ADDENDUM NO. 4

January 30, 2023

Three Rivers Community Schools – Three Rivers Middle School Additions and Renovation

This Addendum consists of Pages ADD 4-1 through ADD 4 - 3, Attached RFI Log, Substitution Request, and GMB Architecture and Engineering Addendum No. 4, dated January 26, 2023, consisting of 4 pages, Reissued Specification Sections; 08 71 00 – Door Hardware, 09 22 16 – Non-Structural Metal Framing, and 09 65 19 - Resilient Tile Flooring, New Sheet; S3.1E, and Reissued Sheets; G0.00, G1.01, G2.01, C8.01, A1.1E, A2.1E, A2.30, A5.01, A6.01, A7.03, A8.01, A8.02, M1.1D, M1.1E, M1.81, M2.1C, M2.1D, M2.1E, M3.1D, M8.01, M8.03, M8.04, M9.01, M9.02, E1.1C, E1.1D, E2.1D, E2.1E, and E7.01.

1
M1.81
ENLARGED UNIT 'D' MECHANICAL MEZZANINE HVAC
DEMOLITION PLAN
1/4" = 1'-0"

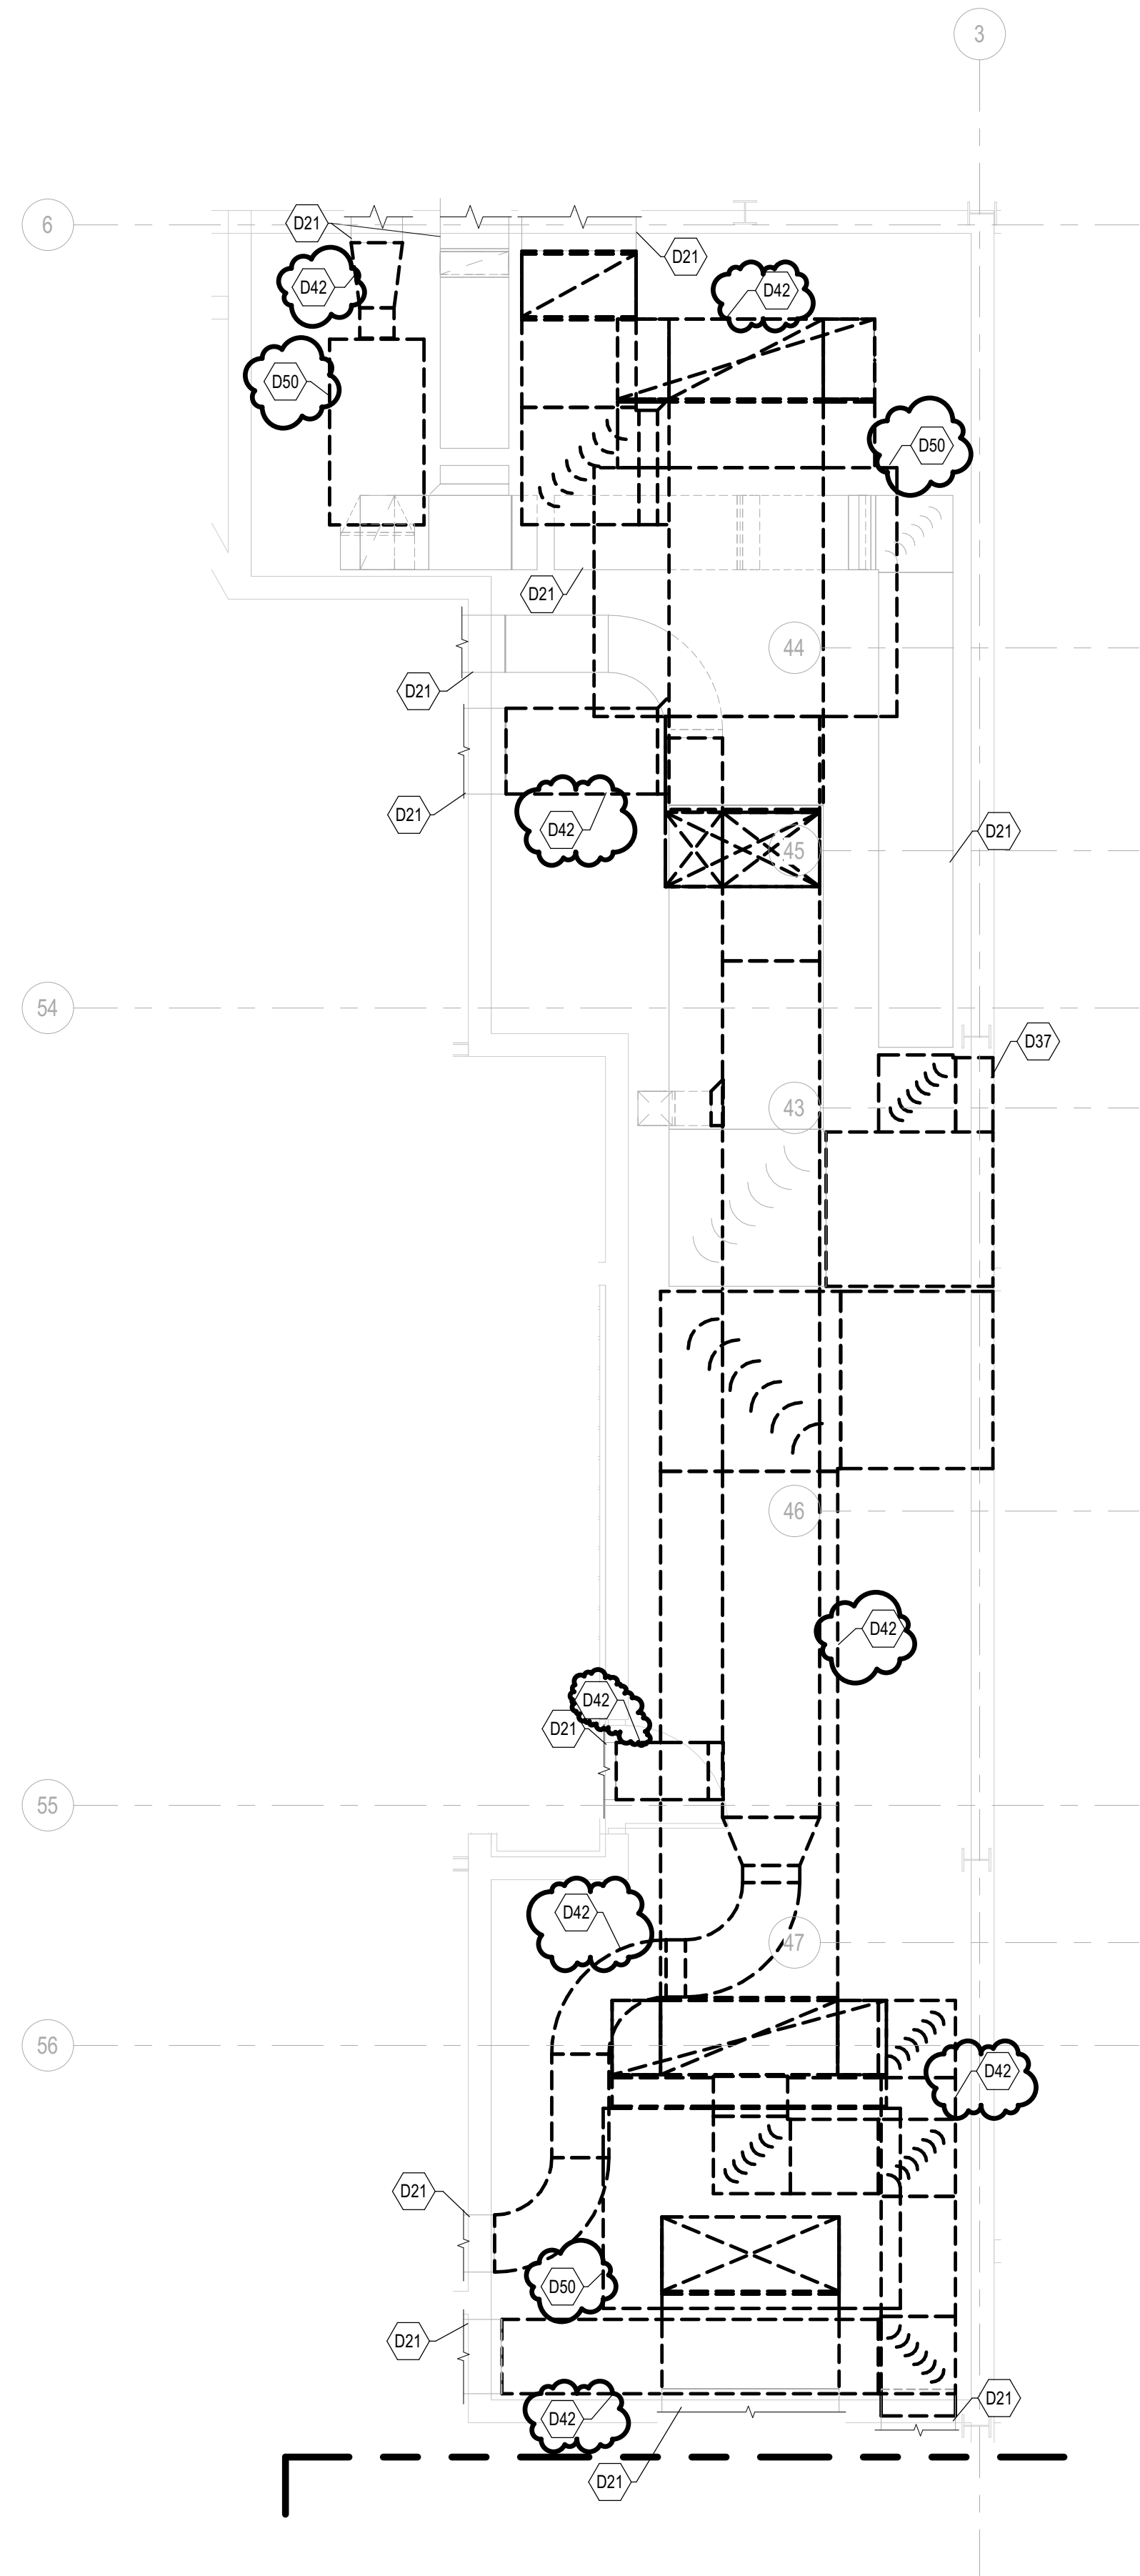
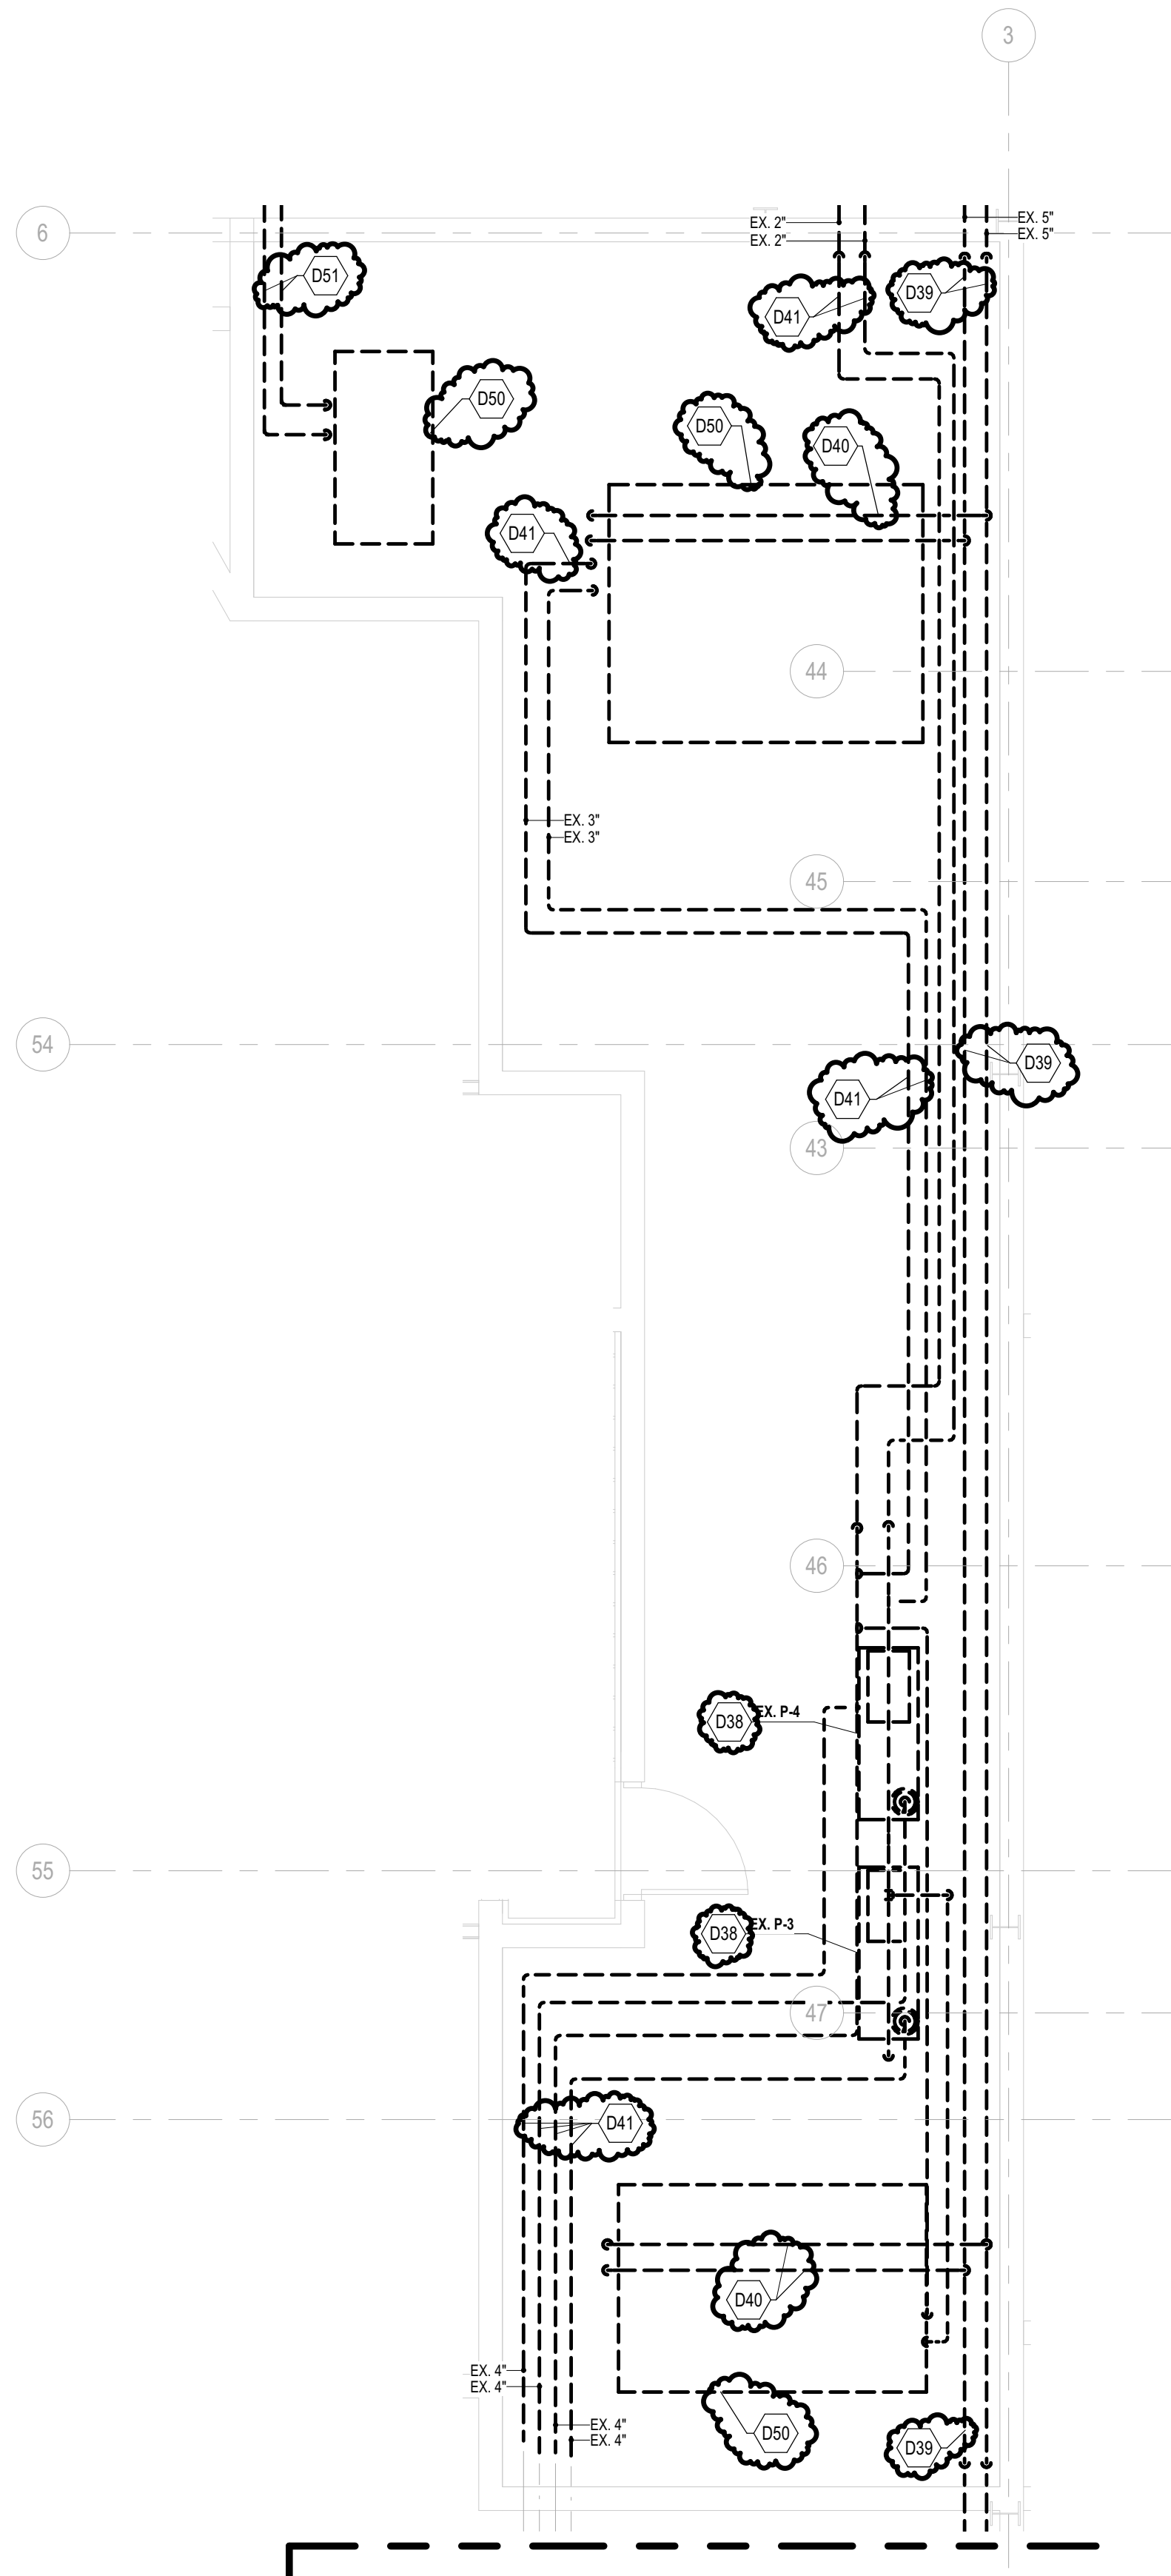
- A. Added and revised mechanical demolition keynotes.
- B. Revised Mechanical Demo Keynote Legend.
